Shoalhaven Starches Expansion Project Modification 27

Modification to RWW Buffer Tank
State Significant Development Modification Assessment
(MP06_0228-Mod-27)

September 2022

Figure 5 | Proposed modifications to Buffer Tank

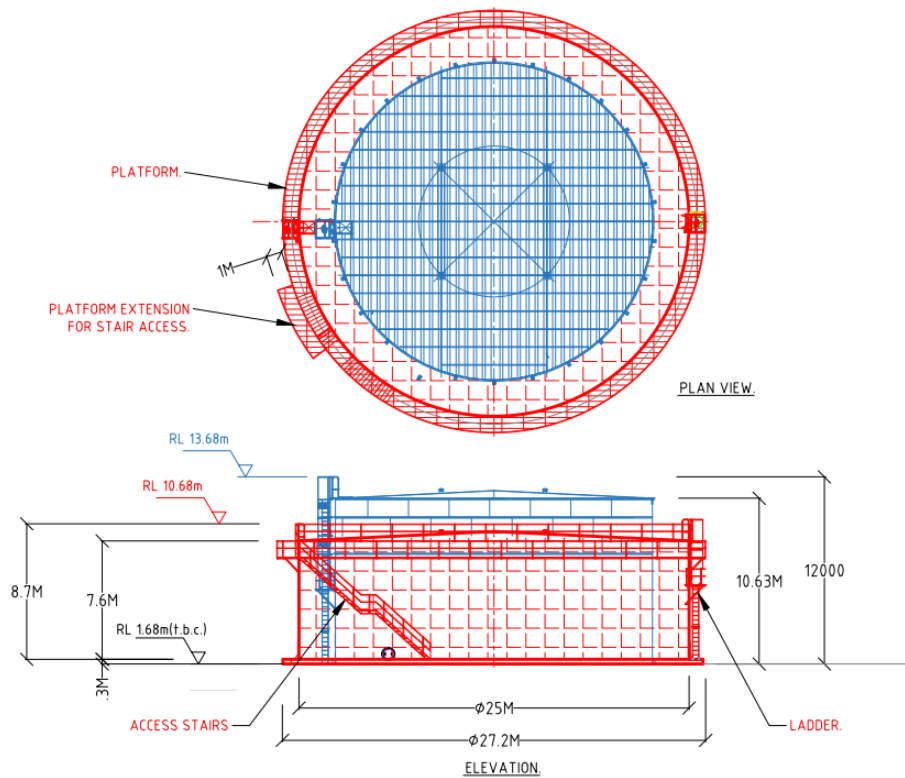
The RWW Buffer Tank was approved under MOD 21 to allow the existing RWW Tank to be taken offline for repairs or any future upgrade works. Following the undertaking of repairs and upgrade works, the Applicant now proposes to use the RWW Buffer Tank as an Equalisation Tank to receive treated water from the Anaerobic Bulk Volume Fermenter (BVF) as part of the WWTP process.

The Equalisation Tank will allow biomass suspended solids that overflow from the BVF process to the Sulfur Oxidisation (SO) Basin to be captured and returned to the BVF. The modification to the tank will result in improved anaerobic effluent quality and provides the BVF with more robustness and stability.

In addition, the diameter and depth of the RWW Buffer Tank is required to be increased to accommodate the settler media equipment inside the tank and to allow for the settling of the solids.

- The modification includes the change in dimensions of an approved RWW Buffer Tank to a reduced height from 10.63 m to 7.6 m and an increased width from 20.3 m to 25 m which could impact on the visual amenity of the location.
